Remedy Optimization Team Report for the Bethpage Groundwater Plume Remedy

- Presented to the Southeast Nassau Water District Committee
June 23, 2011

Navy Bethpage Project Team's Response to Optimization Report

Source: Northrop Grumman's Draft Feasibility Study (FS) Report, Volume 2, Figure 3-2

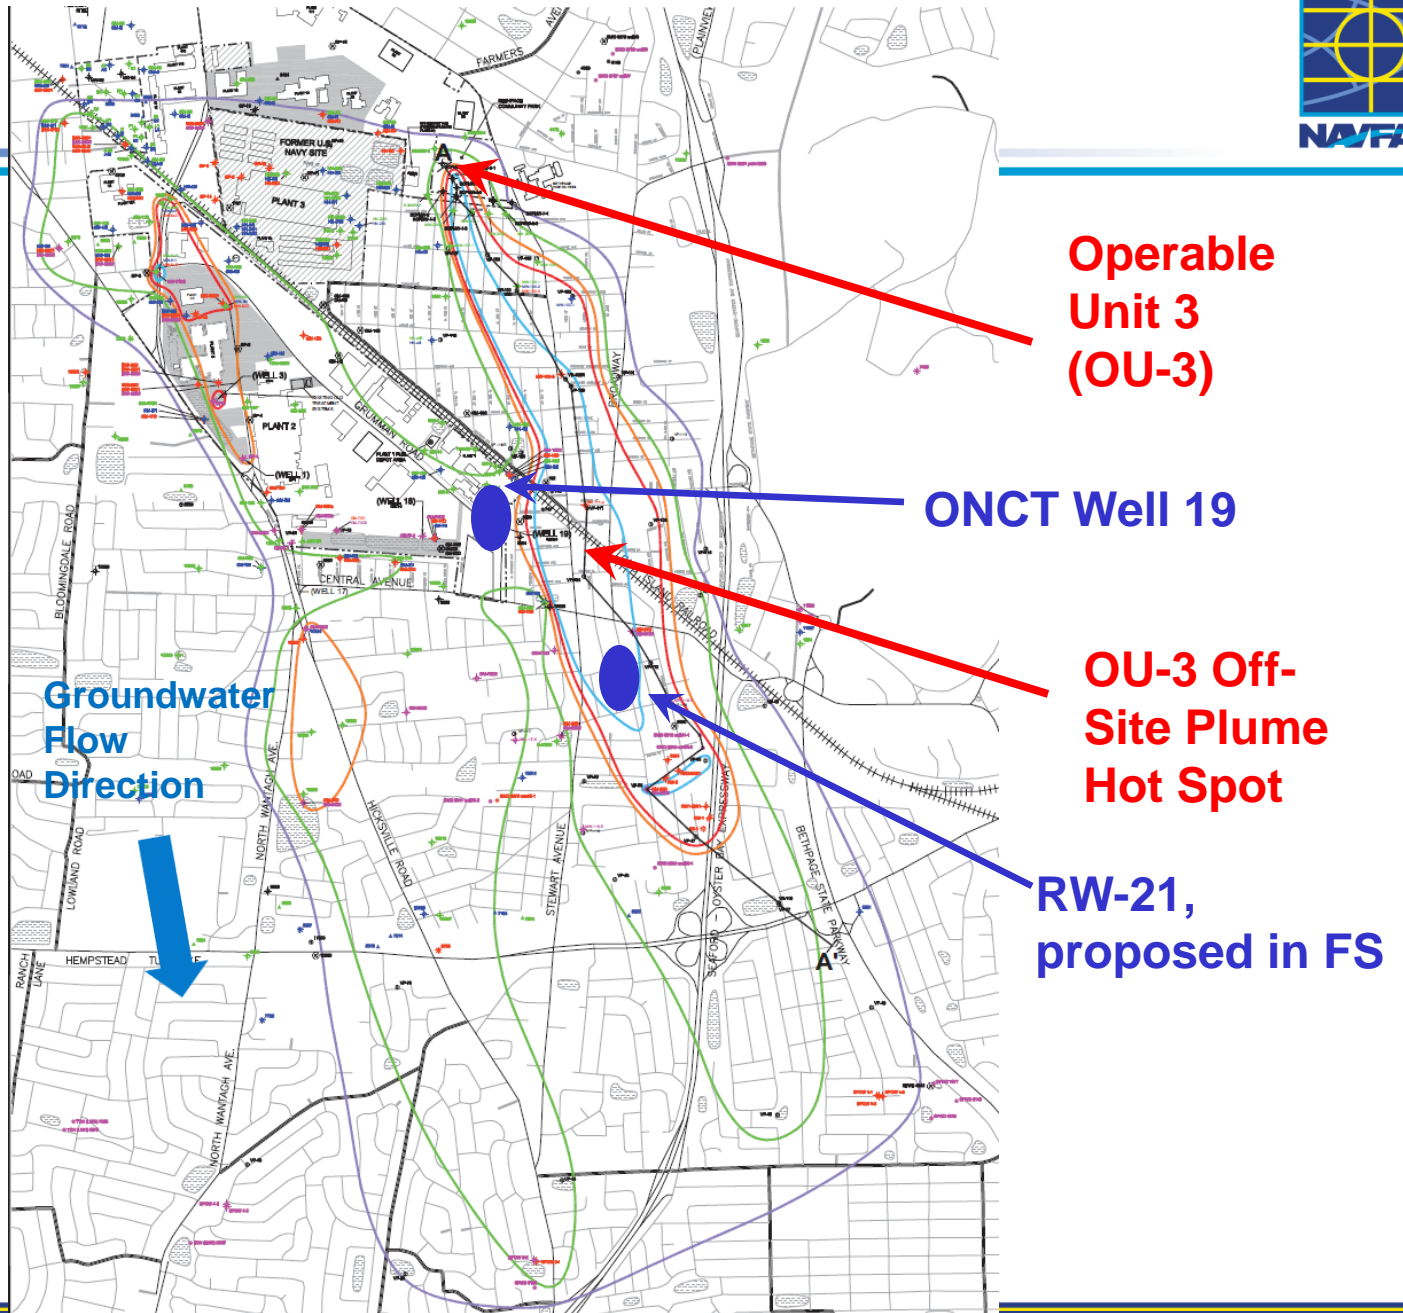
- OU-3 Plume Off-Site Hot Spot

- The OU-3 Plume has an off-site hotspot that represents much higher contamination than in the rest of the off-site plume
 - Recommendation: Use a new extraction well(s) upgradient of Bethpage Water District Plants 4, 5, and 6 to reduce mass discharge across a vertical containment cross-section of the Eastern Plume by at least 90%
 - Recommendation: Avoid reducing the current extraction rate of existing OU-2 well RW-19 to accommodate new extraction wells

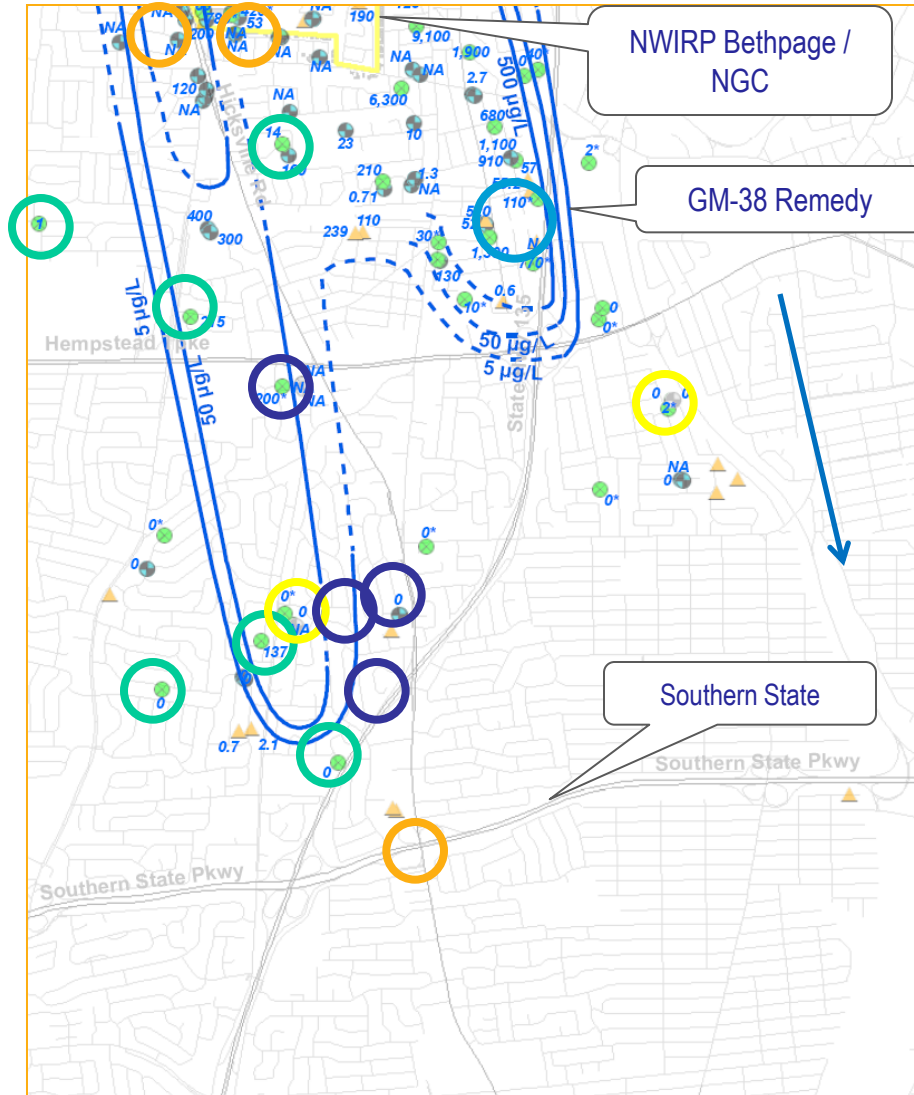
Navy project team has already started implementing higher priority recommendations

1. Installing vertical profile borings and monitoring wells to evaluate containment in deeper portion of the OU-2 aquifer
 - 6 borings in 2009 to delineate boundaries of Western Plume
 - 2 borings and 5 monitoring wells in 2010/ May 2011 for public water supplies
 - 4 borings and 6 monitoring wells planned for 2011/2012 for public water supplies and plume monitoring
 - Borings and wells being evaluated for 2011/2012 for ONCT evaluation
 2. Install monitoring wells/clusters midway between leading edge of plume and Massapequa supply wells to monitor plume progress
 - Boring and wells being evaluated for 2011/2012
 3. Evaluate technical/economic feasibility of plume containment at current leading edge
- Navy will discuss with NYSDEC and NGSC other recommendations.

- 2009 VPBs Installed
- 2010/2011 VPBs and Wells Installed
- 2010/2011 VPBs and Wells In progress (6 months)
- 2011/2012 VPBs and Wells Being Evaluated
